- Subject** ▶ Change on bolt fastening diamond wheel
- For Models** ▶ 4100NB(110mm Cutter),4105KB(125mm Dust less Cutter)
- Description** ▶ As described below, bolt and wrench have been changed.

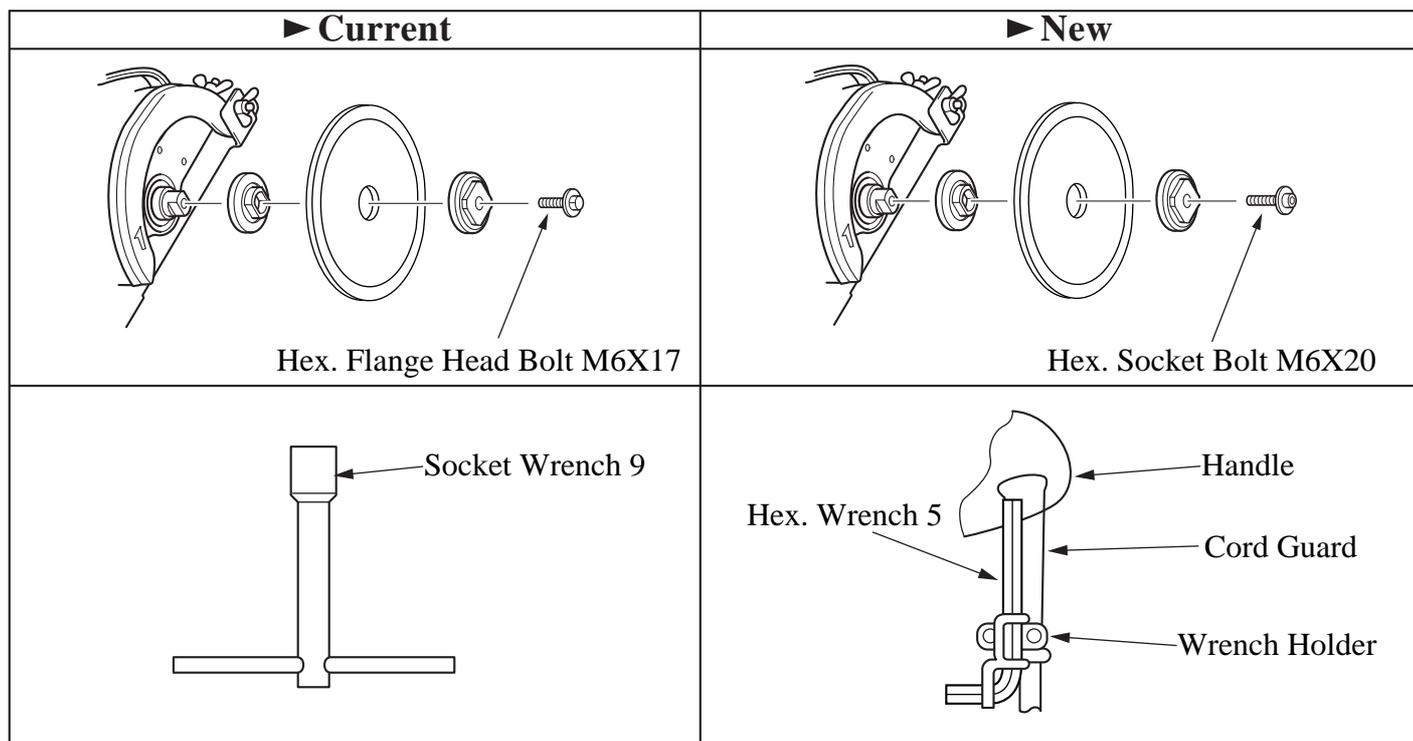
Item No.	Current part	Q'ty	I/C	New part	Q'ty	Note
38	Hex. Flange Head Bolt M6X17 265226-3	1	No	Hex. Socket Bolt M6X20 266133-3	1	Interchangeable as a set
404	Socket Wrench 9 782209-3	1	No	Hex. Wrench 5 783203-8	1	
405				Wrench Holder 5.6 410047-0	1

- 4100NB : From serial No.819330E
- 4105KB : From serial No.32156E
